34.5/115 kV Solar Power Plant & Substation Senior Design Project

Senior Design Team 18 - May 2024

Autocad Site Plan Update

Project Title

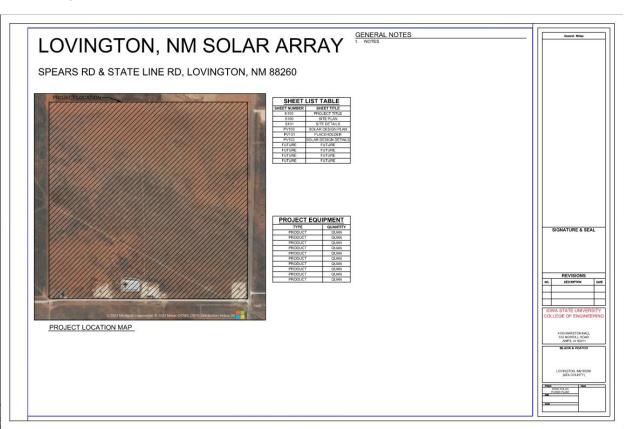
- Change map size
- Add title block info
- Update sheets
- Add Project info

Panel Datasheet

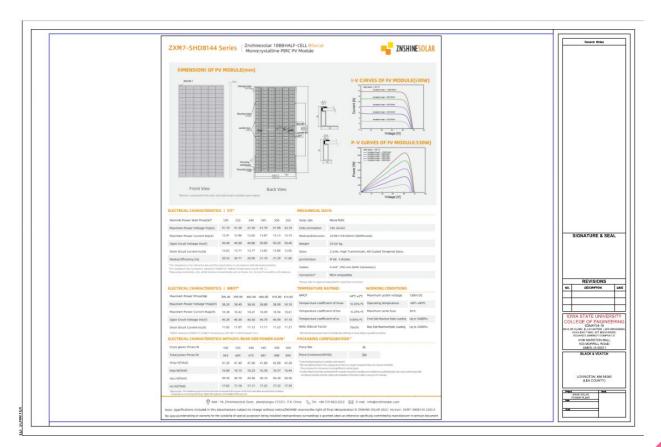
- Change file location
- Add title block info

Combiner Box Datasheet

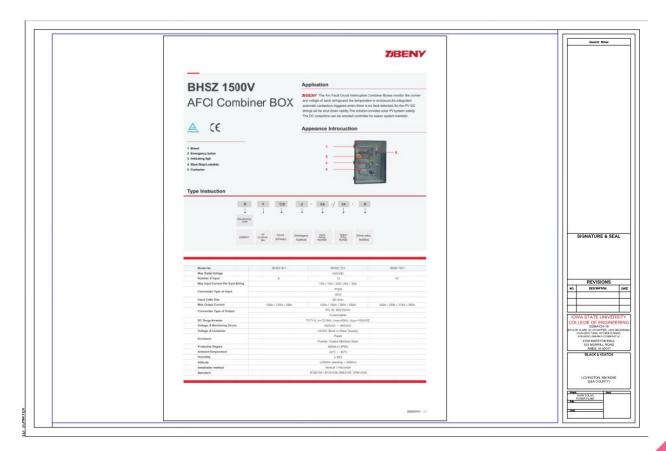
- Change file location
- Add title block info

Skid Inverter Datasheet

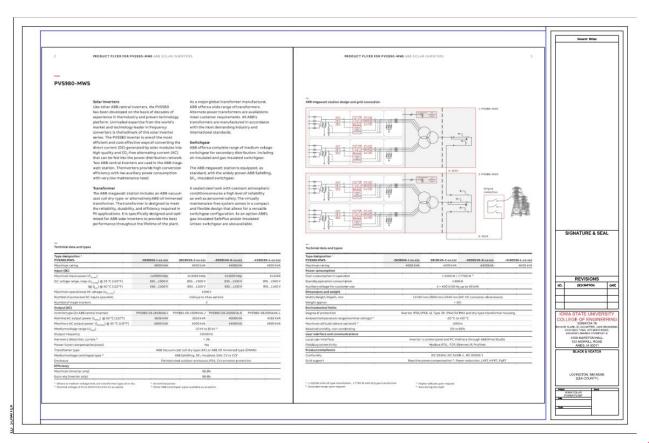
- Change file location
- Add title block info

Layout of Array

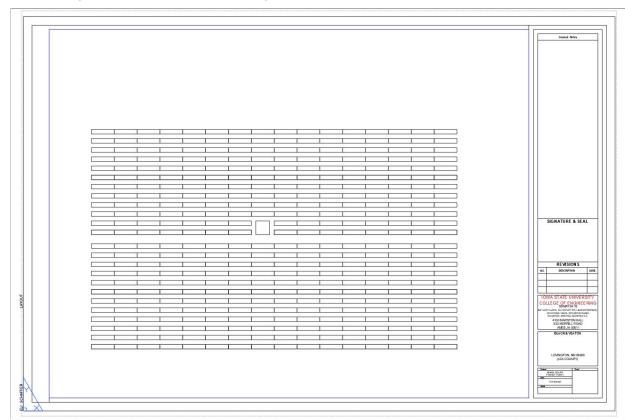
Add title block info
